**Amendments to the Drawings:**

## **REMARKS**

**FIG. 8**

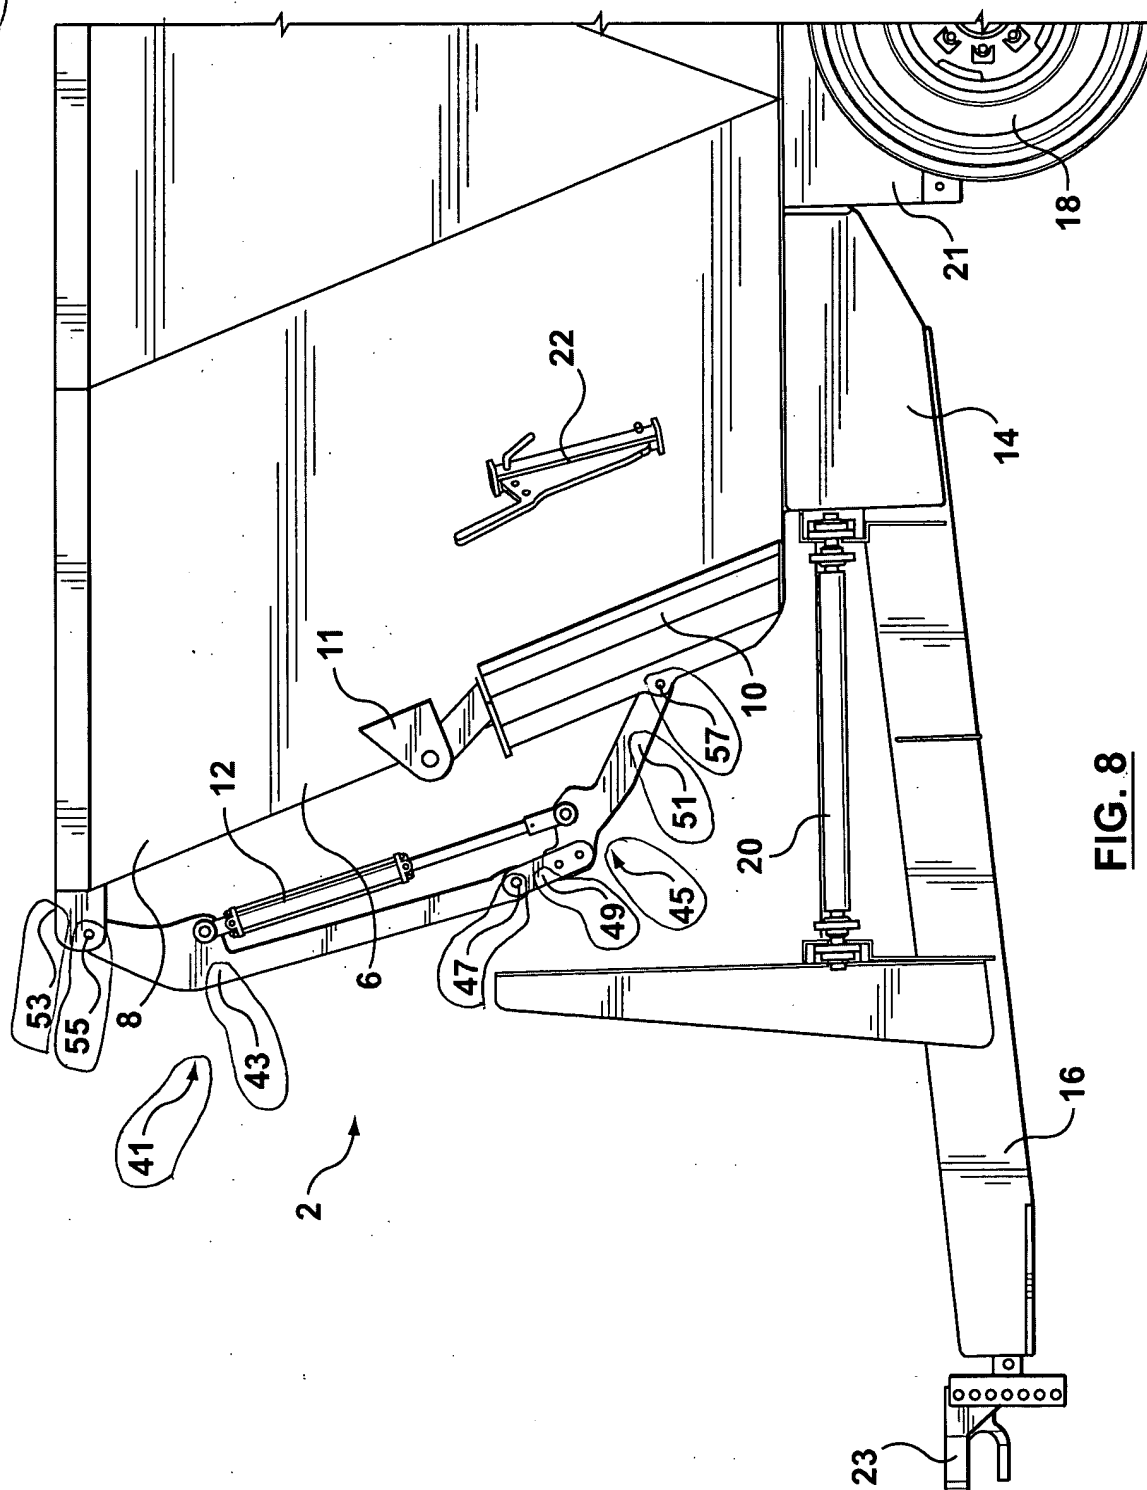
The Examiner indicated that the drawings were objected to as failing to comply with 37 C.F.R.1.84(p)(5), because they did not including the following reference numerals mentioned in the description: 41, 43, 45, 47, 49, 51, 53, 55, and 57.

The attached sheet includes a substitute drawing for Fig. 8. In Fig. 8 certain elements (circled in red) have been added or extended, as described in the Annotated Sheet.

Fig. 8 has been amended by adding the missing reference numerals to that drawing.
